ANB SERIES "FJ", "FH", "FN", "FP", "FQ", "FR", "FS", "FY", "FZ", "RA", "RB", "RE", "RK", "RL", "RM", "RN", "RQ" TYPE

USE FOR MODEL <div><input type="checkbox"/> K <input type="checkbox"/> N <input type="checkbox"/> S <input checked="" type="checkbox"/> A <input type="checkbox"/> R <input type="checkbox"/> B <input type="checkbox"/> T <input type="checkbox"/> D <input type="checkbox"/> P</div>		<div><div>SIAM COMPRESSOR INDUSTRY CO., LTD.</div></div>			REFERENCE : CS01F761			
					TITLE COMPR. OUTLINE DWG.			
	DIM. IN mm.	DATE	11-09-05	APPROVED	S.DUMRONGSAK	DWG. No.	SC01F129	1/1
	SCALE	DRAWN	K.WILAILAK					
		CHECKED	C.SUWAT					
	DESIGNED	W.CHOMPOONOOT

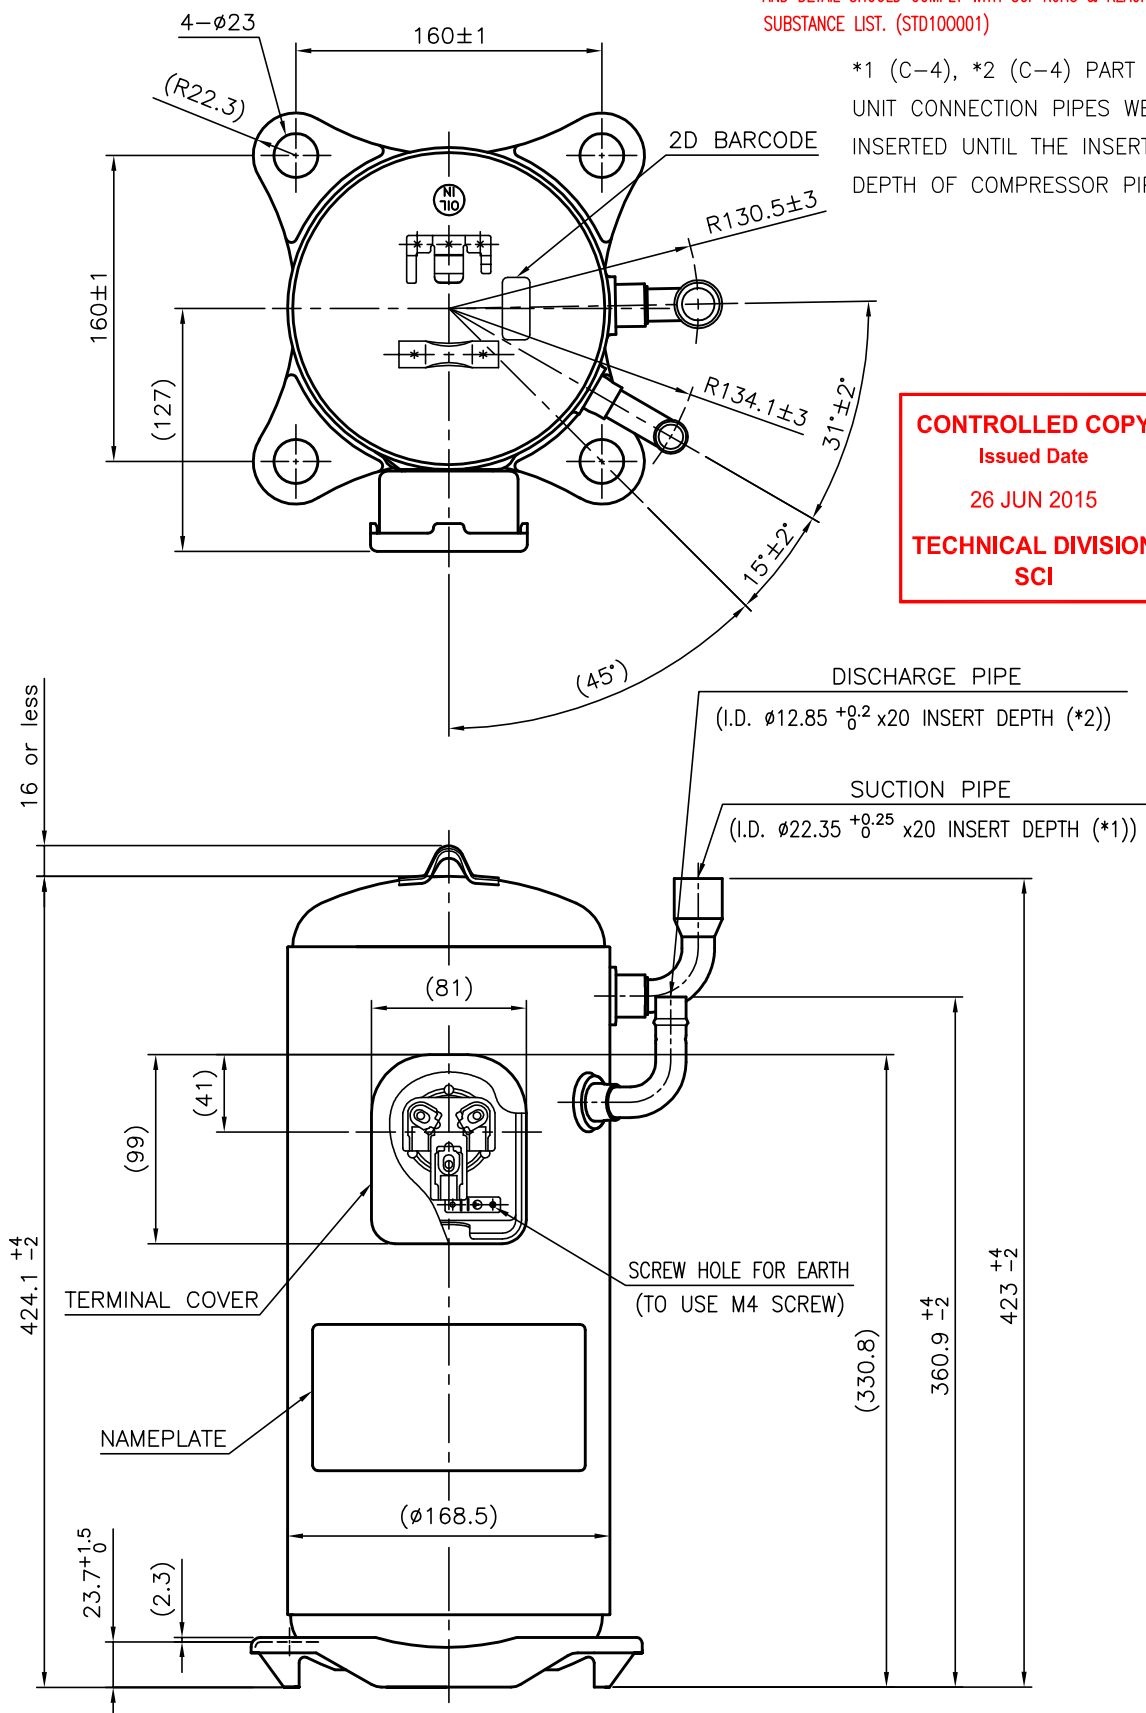
"RA", "RB", "RE"
TYPE WERE ADDED.
12-03-29

[B1] (D-2)
MODEL NAME AND
MANUFACTURE DATE
WERE CANCELLED.
12-06-28
I.AMPOL
S.DUMRONGSAK
(NO. NCQ1210141)

[C1] (D-4)
C1 WAS 360.9.

[C2] (D-4)
C2 WAS 423.
12-10-25

[D1] (A-3)
OIL IN WAS ADDED.

[D2] (F-2)
"FU" TYPE WAS
CANCELLED.

[D3] (F-3)
"FZ" TYPE WAS
ADDED.
13-08-25

[E1] (F-3)
"RK", "RL", "RM"
TYPE WERE ADDED.
14-02-05

[F1] (A-1)
FORM WAS CHANGE.

[F2] (B-3)
R130.5±3 WAS R130.5.

[F3] (B-3)
R134.1±3 WAS R134.1.

[F4] (B-3)
31'±2" WAS 31'.

[F5] (B-3)
15'±2" WAS 15'.

[F6] (D-4)
360.9 ±₂ WAS
360.9 ±₃.

[F7] (D-4)
423 ±₂ WAS 423 ±₃.

[F8] (D-1)
424.1 ±₂ WAS
424.1.

[F9] (E-1)
23.7 ±_{1.5} WAS 23.7.

[F10] (F-4)
"RQ", "RN" TYPE
WERE ADDED.
14-05-21
